Date: November 4, 2019
To: Beth Callahan, Project Manager, Maine Department of Environmental Protection
Karem Gungor, Environmental Engineer, Maine Department of Environmental Protection
From: Elizabeth M. Ransom, P.G. Ransom Consulting, Inc.
Subject: Nordic Aquafarms, Inc., Land-based Aquaculture Facility, Belfast, Maine
L-28319-26-A-N, Review Comments

This memo provides responses to the Technical Review Memorandum from Karem Gungor to Beth Callahan dated October 3, 2019. For clarity, the entire comment from the technical memorandum has been copied below and italicized. Responses are in regular text, and on the attached plans and figures as referenced below.

SOIL EROSION & SEDIMENT CONTROL PHASING PLAN -1
PHASE 1 SITE CLEARING
SHEET TITLE:

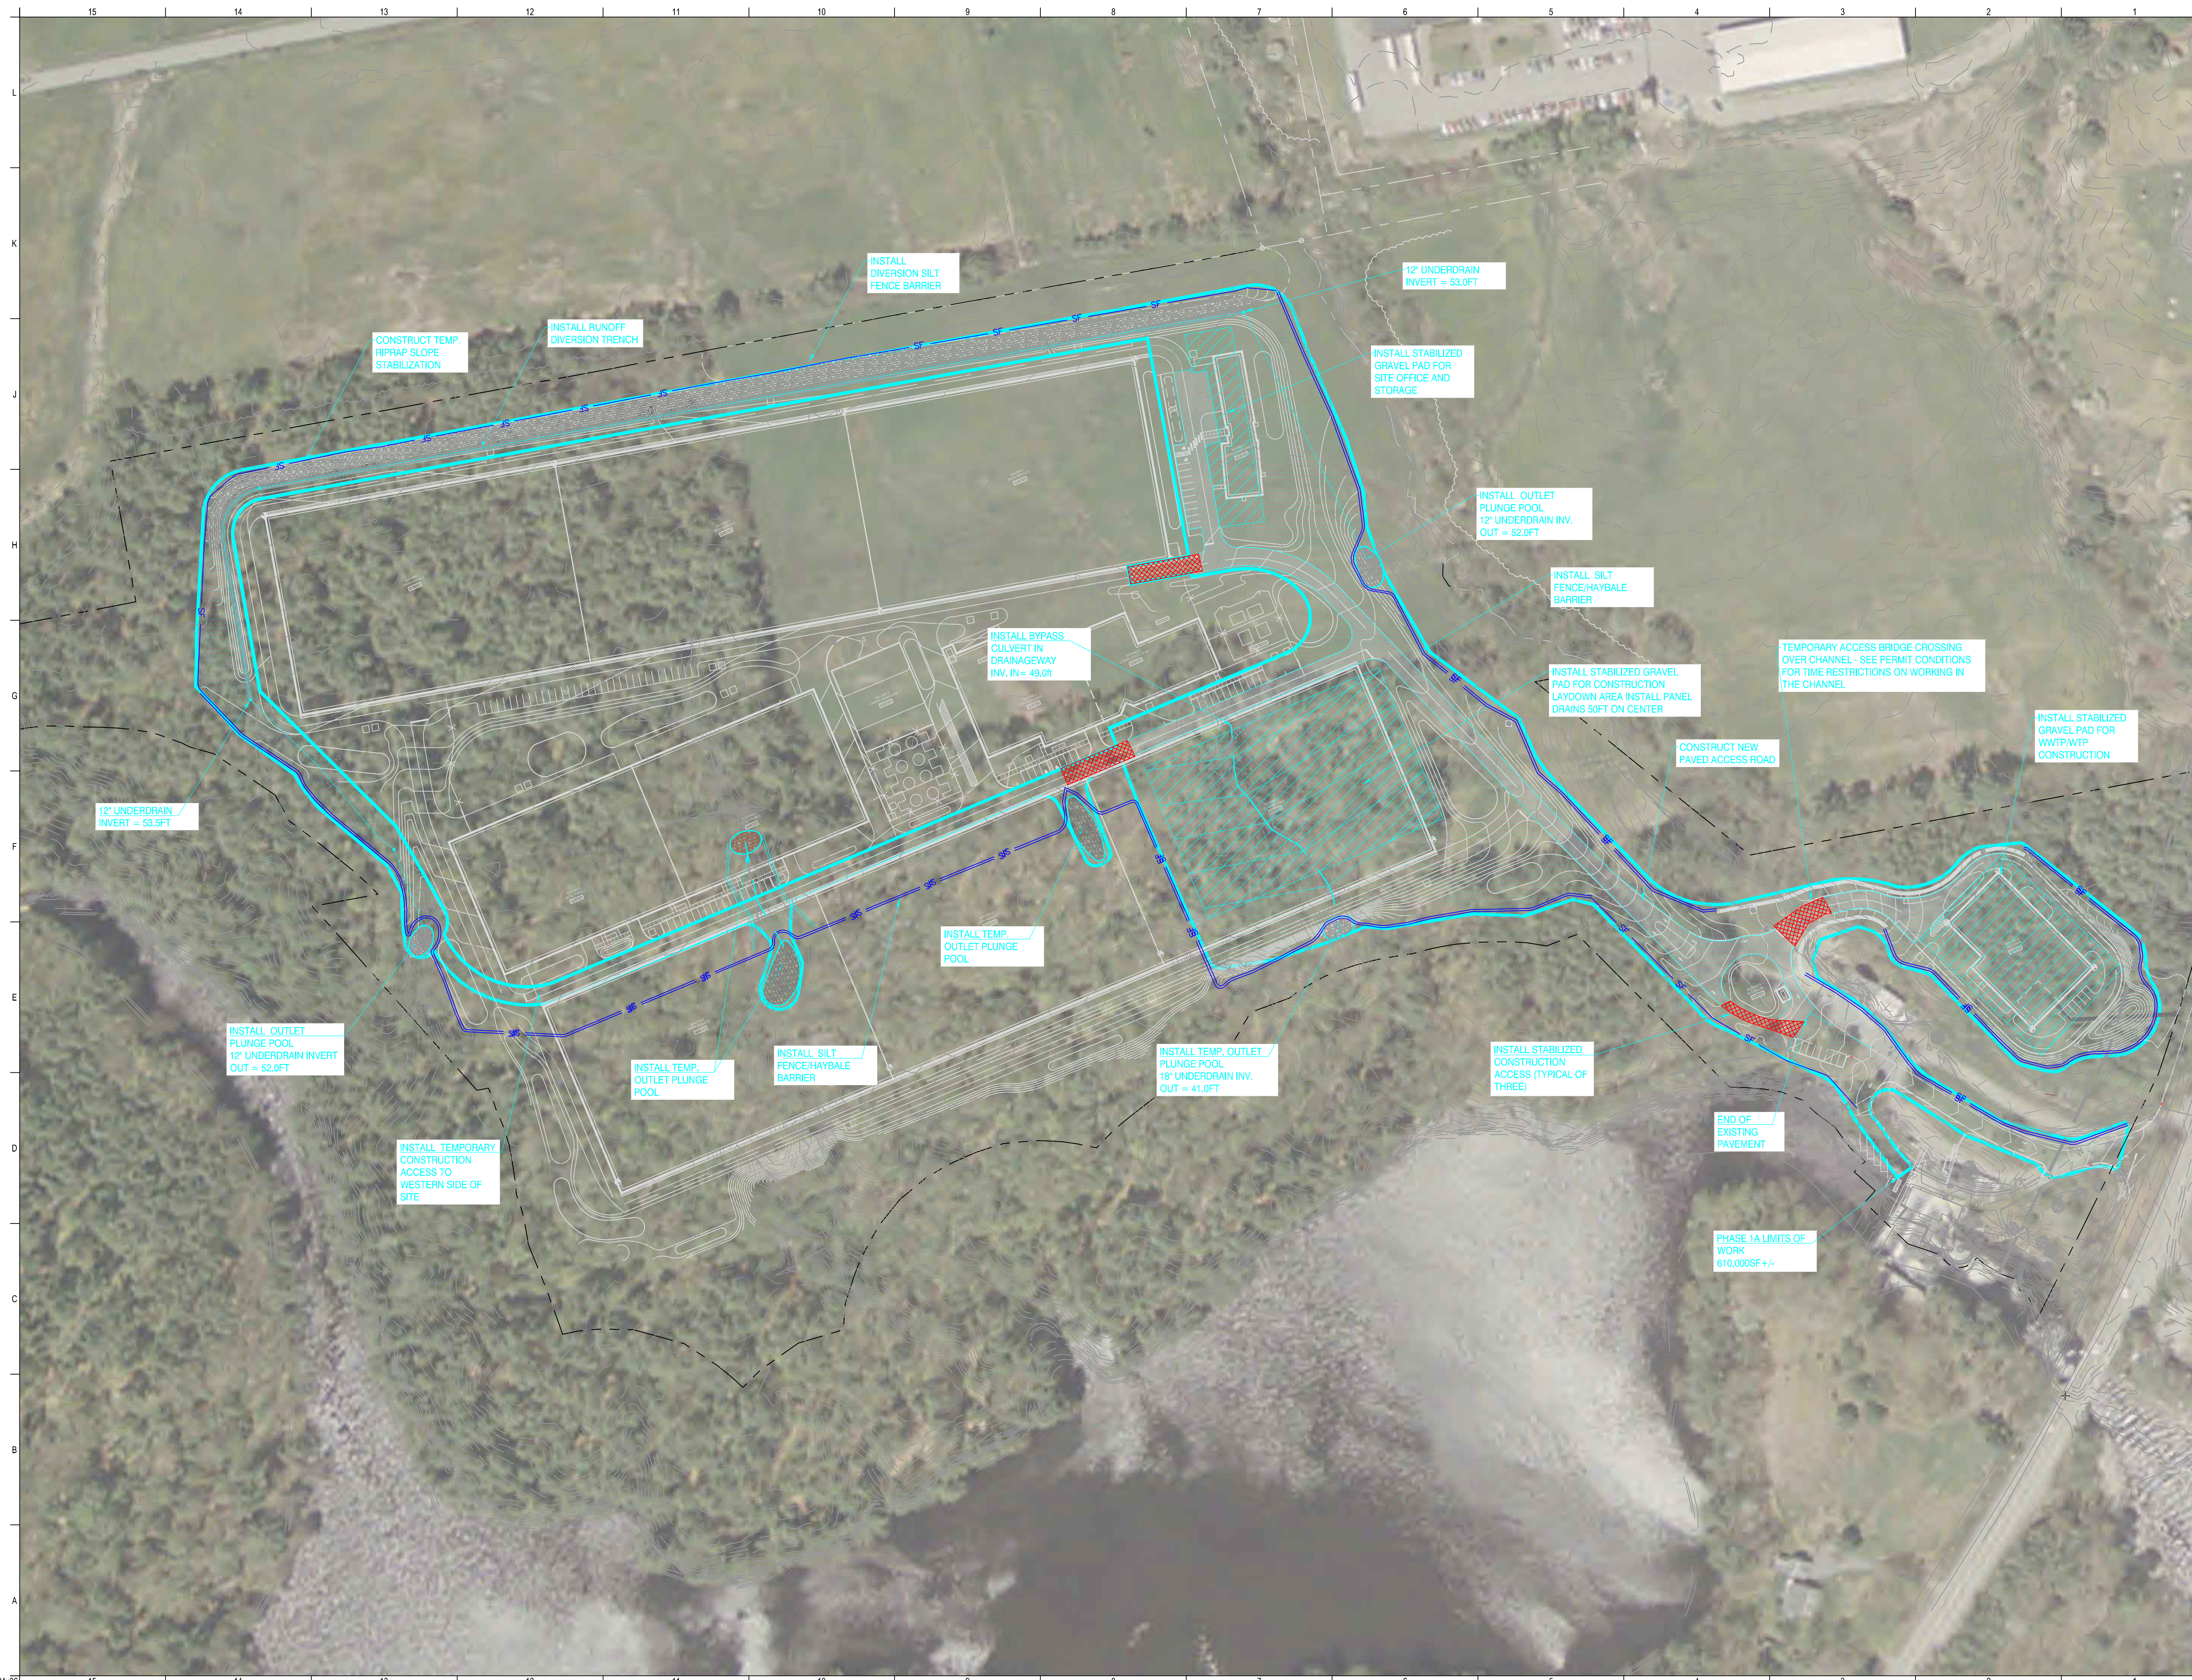
1. First Diversion Trench (Sheet CE111): This trench will not be connected to the edge drain/culvert bypass system as shown in the ESC phasing plans. The trench will intercept the surface runoff from approximately 8.5 acres of upgradient area (see south of Subcatchment 9 flow path in Sheet CW-102) which appears to shed into the streams S3, S5, and S6 under the existing/pre-development conditions. The intercepted flow (surface runoff+ groundwater) will be discharged into an easterly plunge pool based on the underdrain invert elevations provided in Sheet CE111. I recommend the following:

A revised Section 14 Erosion and Sedimentation Control (ESC) Plan has been included as **Attachment A**. Revised phasing plans are included as **Attachment B** and revised phasing plans with aerial background imagery are included as **Attachment C**. Drawings and narratives described in the responses below can be located in the respective attachments.

SOIL EROSION & SEDIMENT CONTROL PHASING PLAN -5
PHASE 1D
SHEET TITLE:

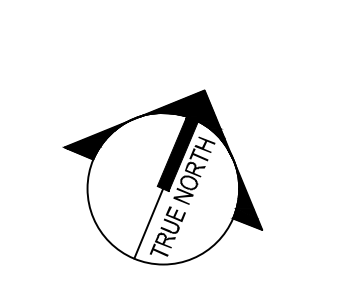
TIE EXCAVATION EDGE DRAINS INTO DIVERSION TRENCH DRAIN
